ADDENDUM NO. 1
TO
PROCUREMENT AND CONTRACTING REQUIREMENTS
FOR
NineStar CR200 Sewer – Division I
FOR
NINESTAR CONNECT
Issue Date: October 25th, 2023

The following, as additions to and modifications in the Bidding Requirements and Contract Documents, will be included in, and become a part of the **NineStar CR200 Sewer – Division I**. This Addendum forms a part of the Contract Documents. Bidders are, therefore, instructed to take the following into account in rendering any Bid for this work. Acknowledge receipt of this Addendum in the space provided on the Bid Form.

E305

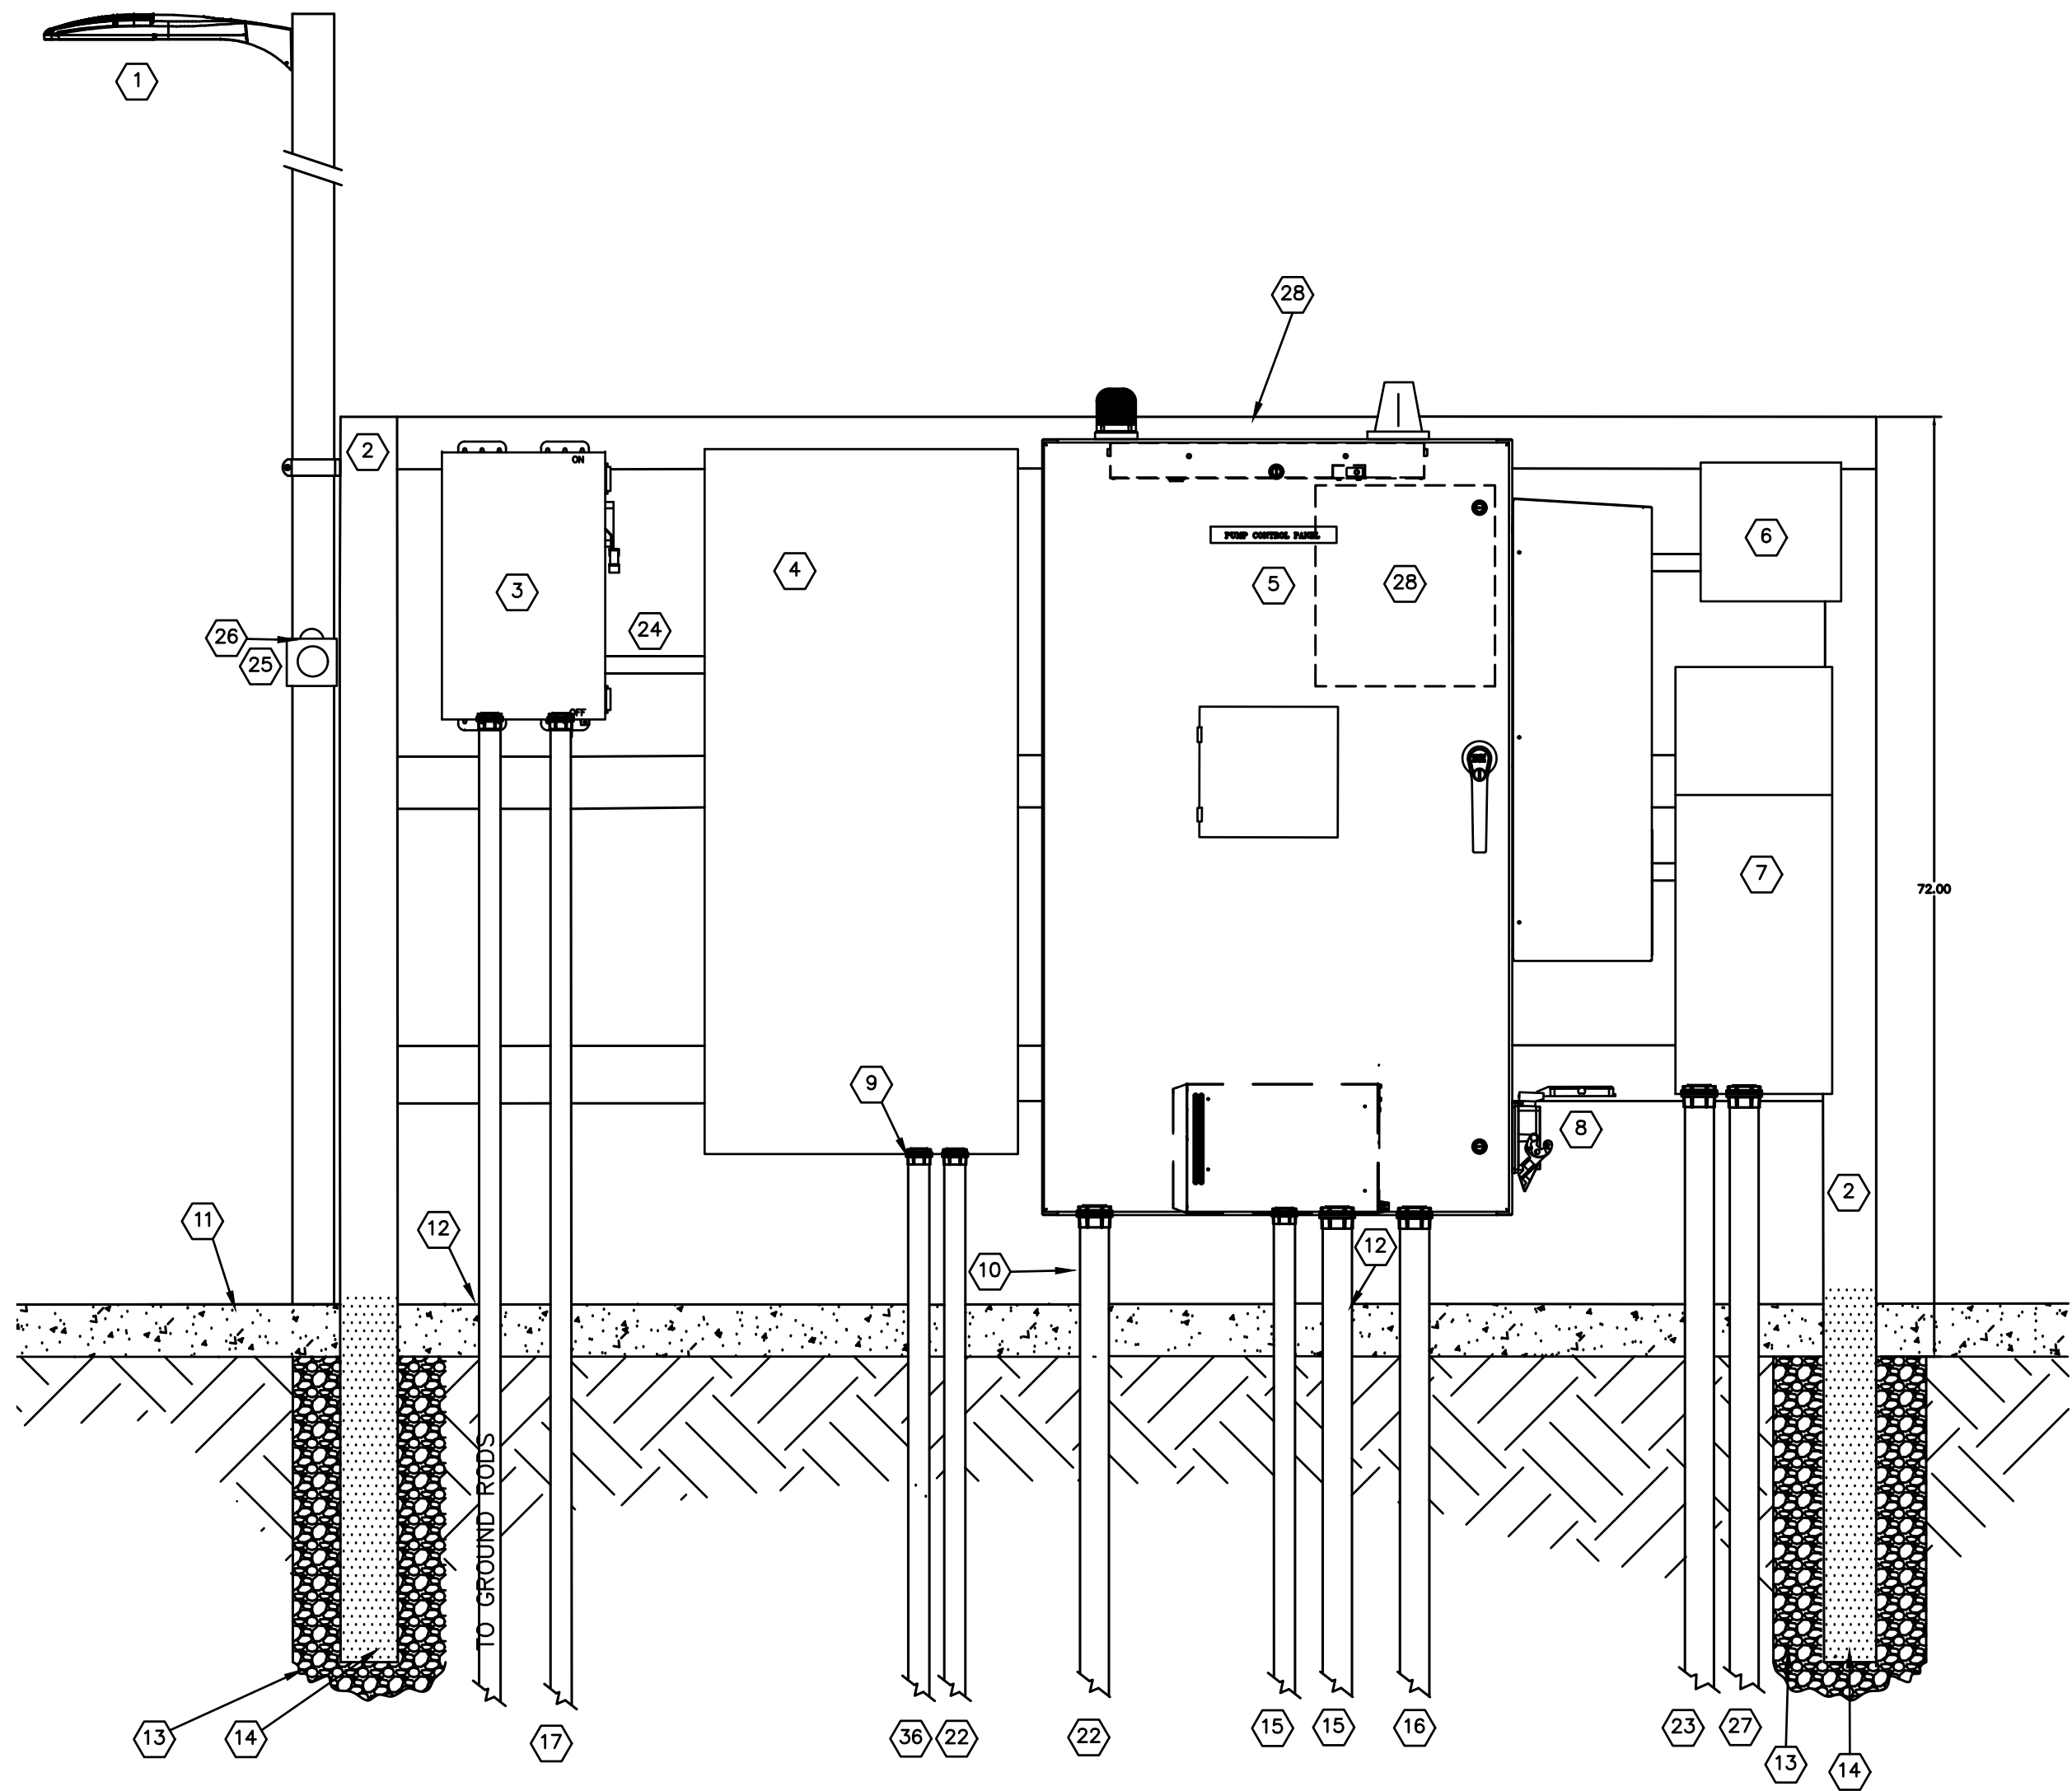
- r. Sheet E305 – CR300 Pump Control Panel Wiring Diagram (OL1 and OL2 removed as there is no motor starter. Removed “pilot light” from alarm beacon circuit note.)

E403

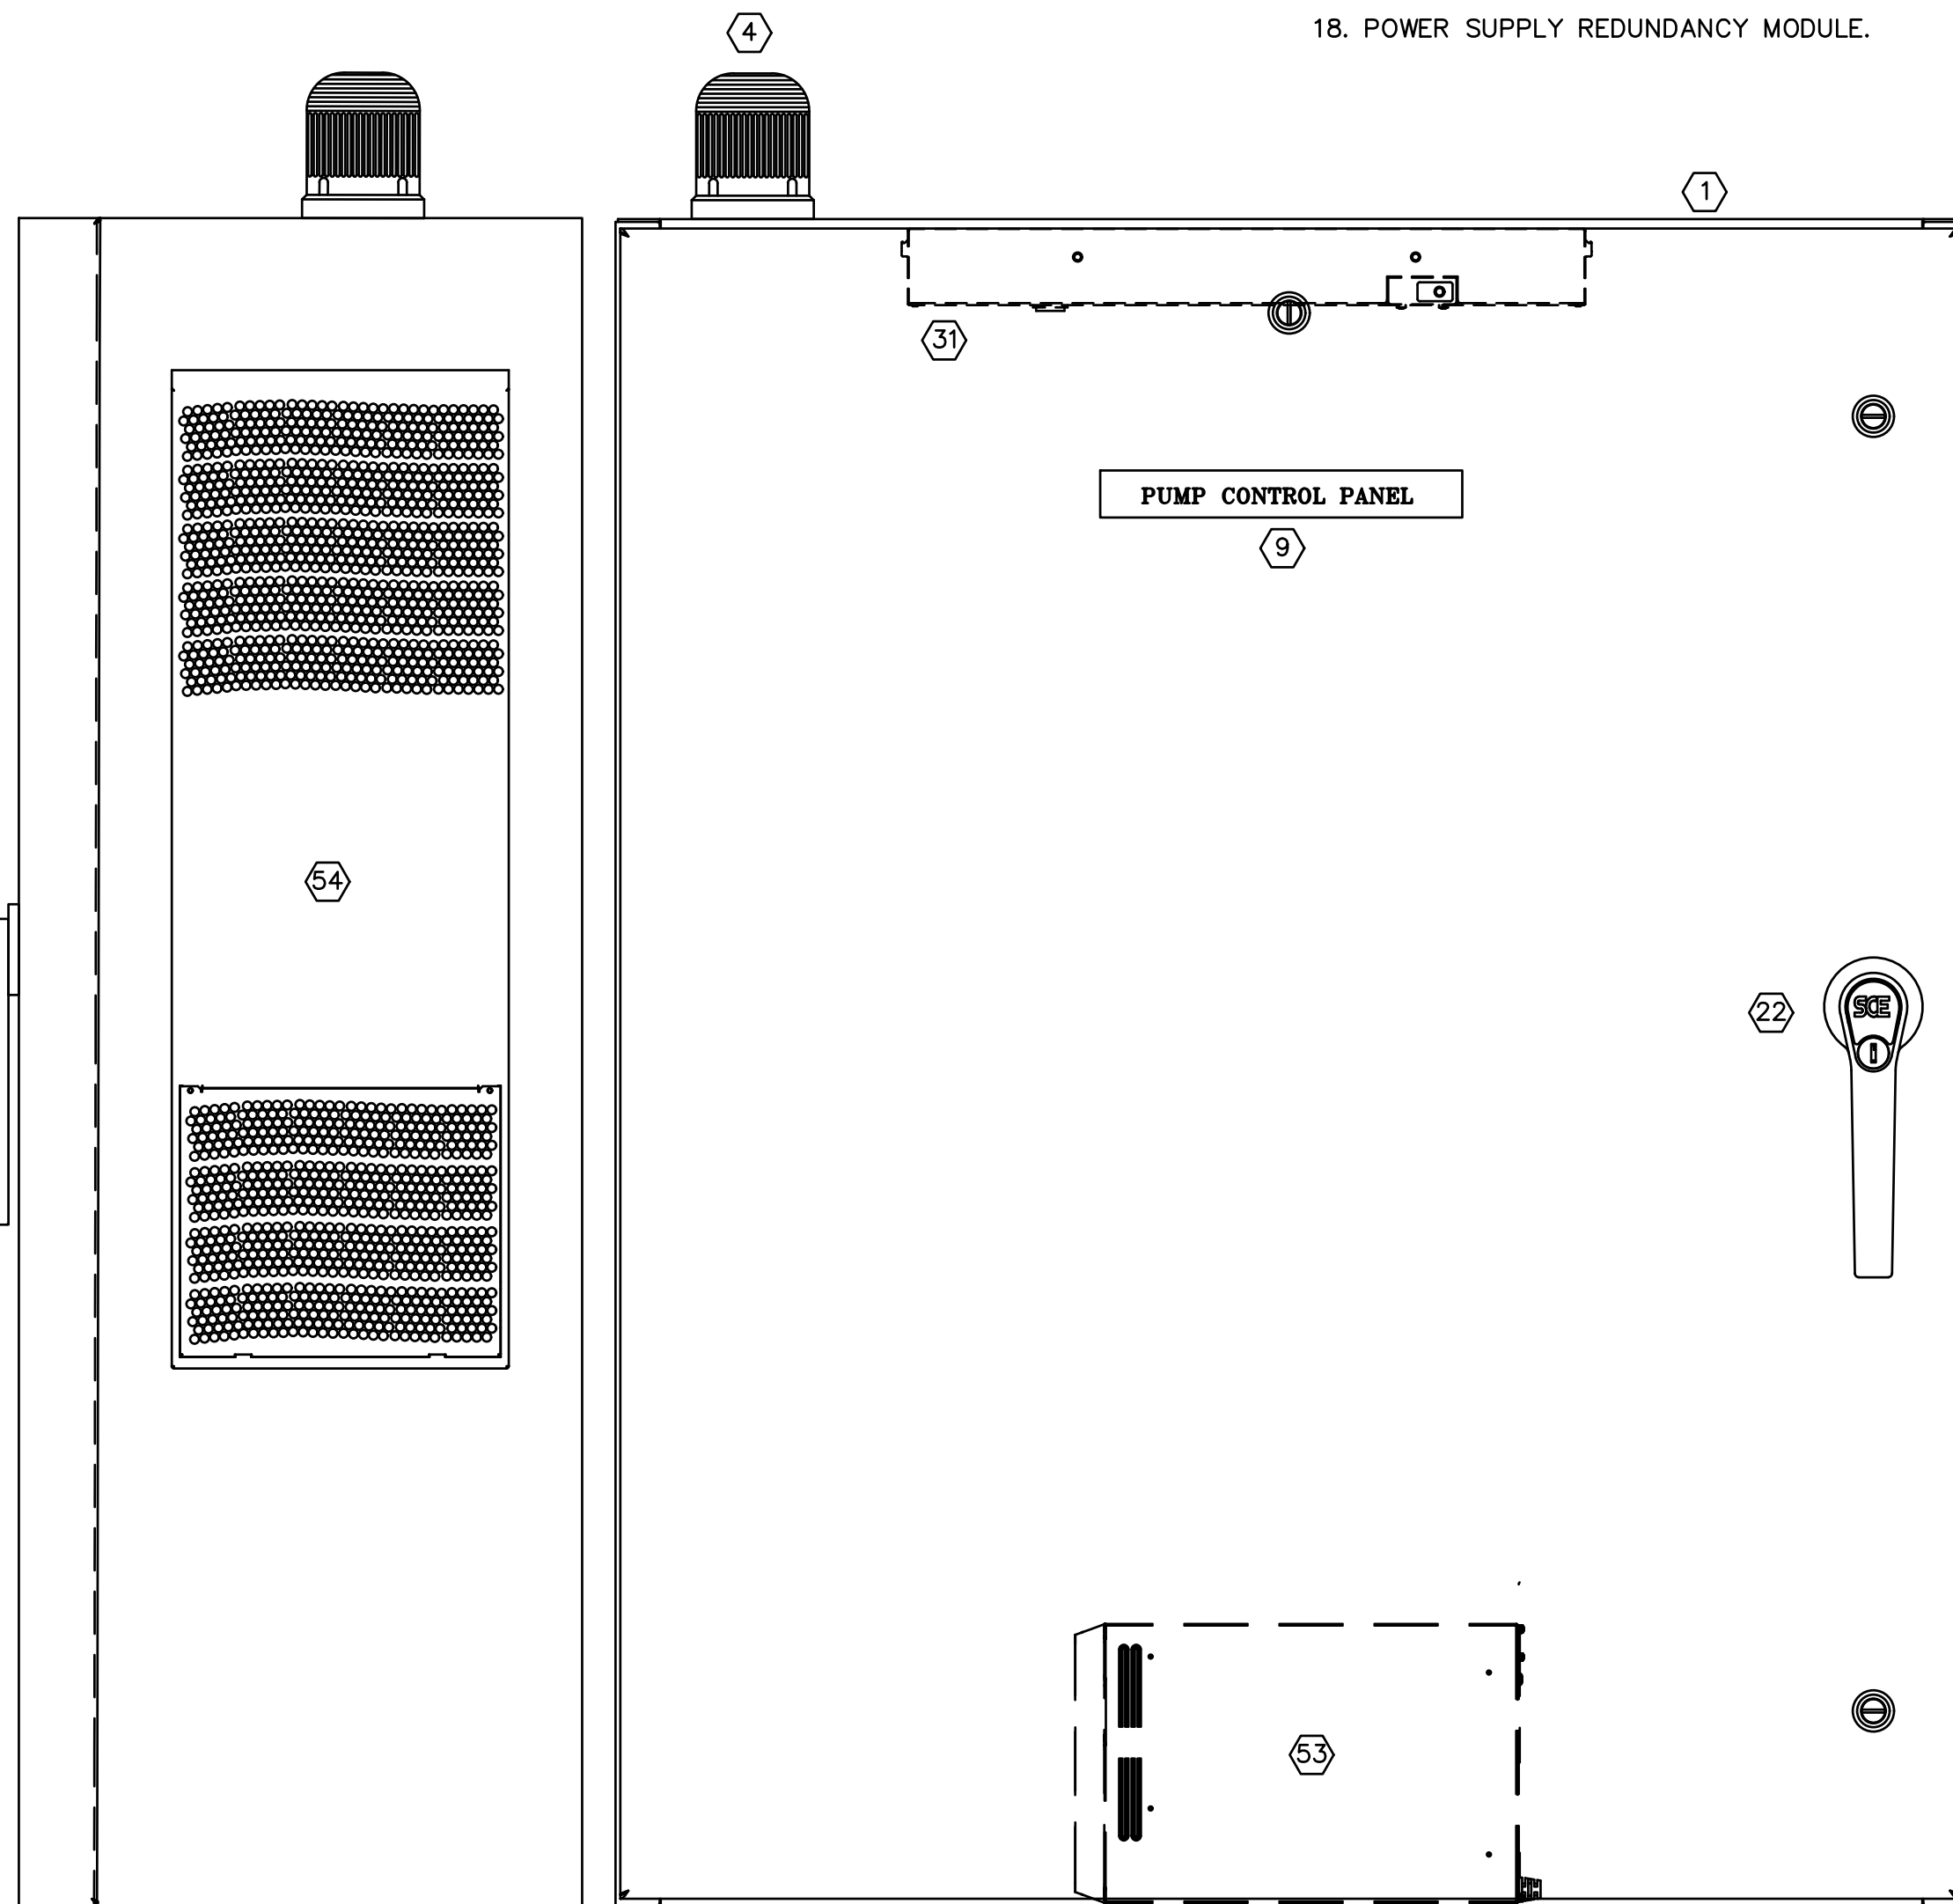
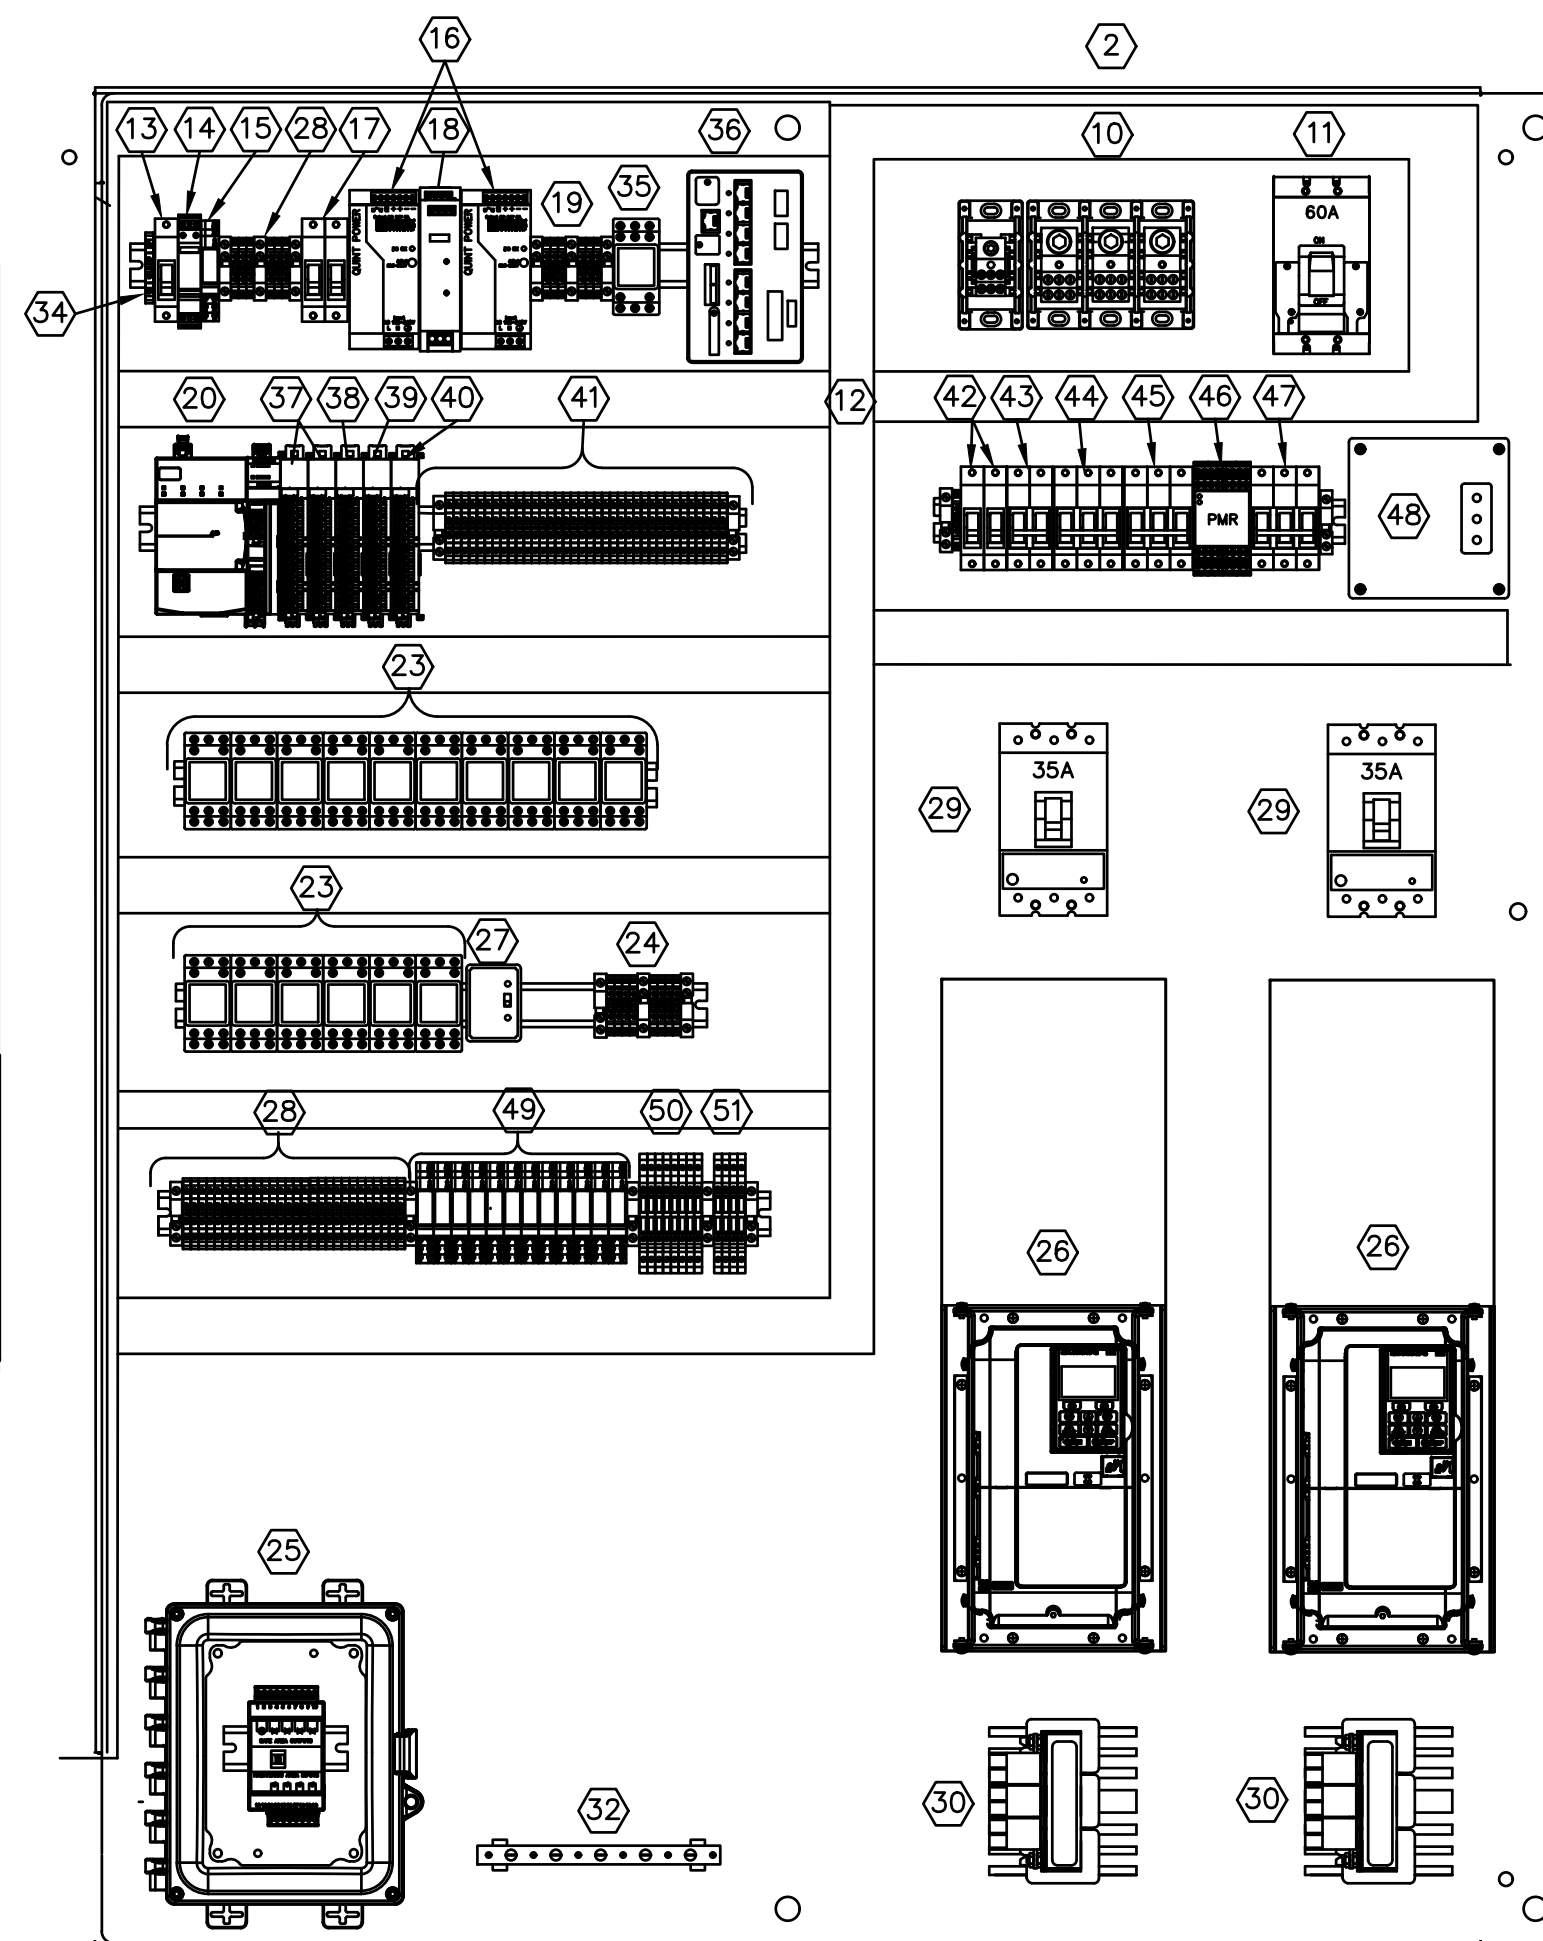
- s. Sheet E402 – Sugar Creek Lift Station Electrical Details (Coupling in vented channel removed.)
- t. Sheet E403 – Sugar Creek Pump Control Panel Layout Details (Added note about AC/Unit heater.)
